PMSTPCOL PEmails

From: Brad Harvey
Sent: Friday, August 22, 2008 3:58 PM
To: Ramsdell, James V Jr (Van)
Cc: Paul Kallan; Raj Anand; Charles Cox; STPCOL
Subject: STP COL FSAR EAB & LPZ X/Q Values
Attachments: RAI Letter_06122008.pdf

South Texas Project
Units 3 and 4
Docket Nos. 52-012 and 52-013
Response to Requests for Additional Information

FIGURE 9.3-11 PIPING AND INSTRUMENTATION DIAGRAM, RADIOACTIVE DRAIN TRANSFER (SHEET 7 OF 22)

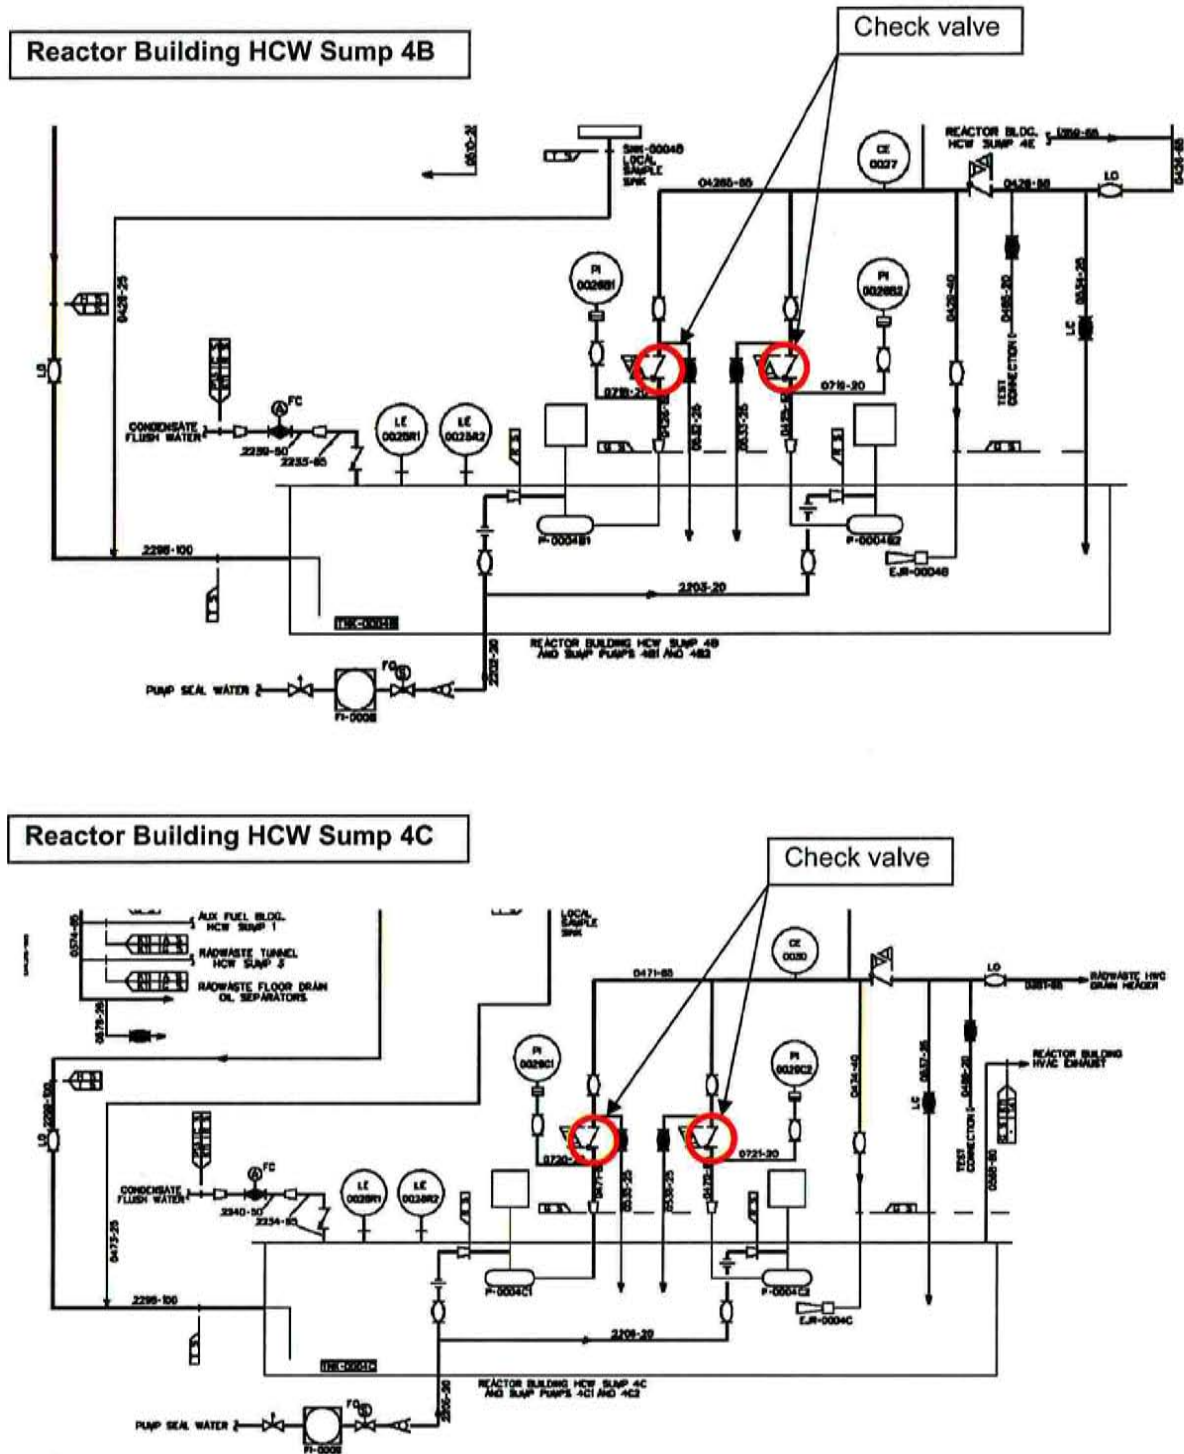
ABWR DCD Section 9.3.8.1.1, "Safety Design Bases" Item 5(a) states that backflow check valves should be included in the ECCS equipment room sumps. Item 5(b) states that floor drain piping in each divisional area of the ECCS pump rooms and the Control Building shall be arranged so that flooding or backflow in one quadrant will not adversely affect other quadrants. The staff could not locate in the P&IDs the check valves and sumps for each ECCS equipment room. Please include these components (or add a reference to) in COLA FSAR Figure 9.3-11.

The drains from the ECCS equipment rooms A, B and C are collected in the individual HCW sumps located in each room. The sumps are HCW Sump 4A on Sheet 6 of Figure 9.3-11, and 4B and 4C on Sheet 7 of Figure 9.3-11. The sump pump is actuated on a water level high signal to prevent flooding. The suction line of each of the relevant sump pumps has a check valve to prevent backflow. The check valve is located in the HCW sump in the individual ECCS equipment room.
